HIGHWAY WORK PROPOSAL

<u>COUNTY</u>	<u>STATE PROJECT</u>	<u>FEDERAL</u>	<u>PROJECT DESCRIPTION</u>	<u>HIGHWAY</u>
Forest	9260-00-70	N/A	Crandon - Three Lakes; Crandon Rr Overhead To Railroad Ave	STH 032
Forest	9261-07-62	N/A	Crandon - Three Lakes; Crandon To Argonne Culverts	STH 032

Addendum No. 01
 ID 9260-00-70
 Revised Sheet 7
 March 2, 2022

4. Traffic.

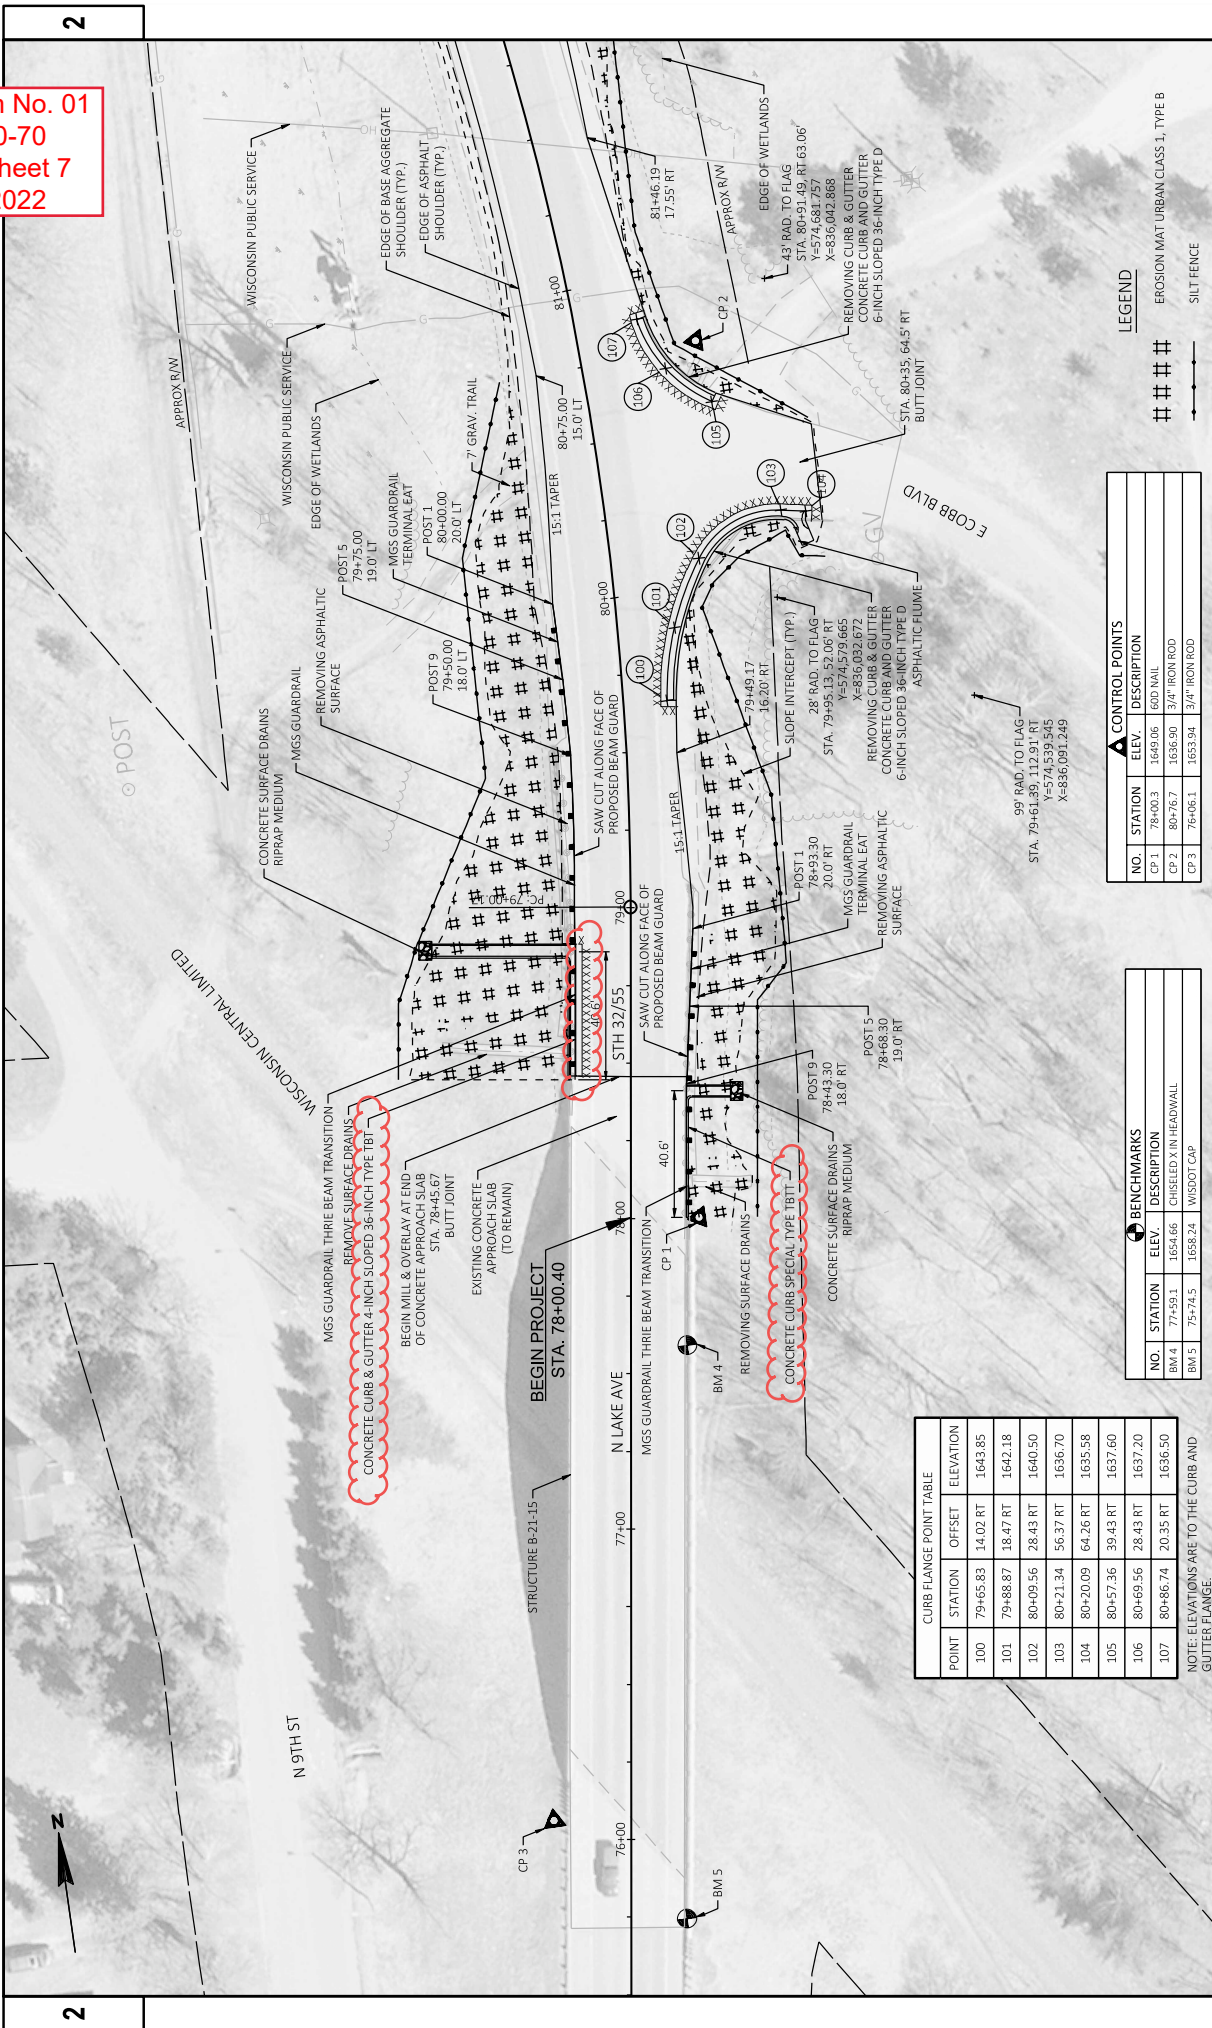
Replace paragraph six with the following:

Maintain a minimum distance of one mile between lane closures or flagging operations. Limit flagging operation to 2 miles.
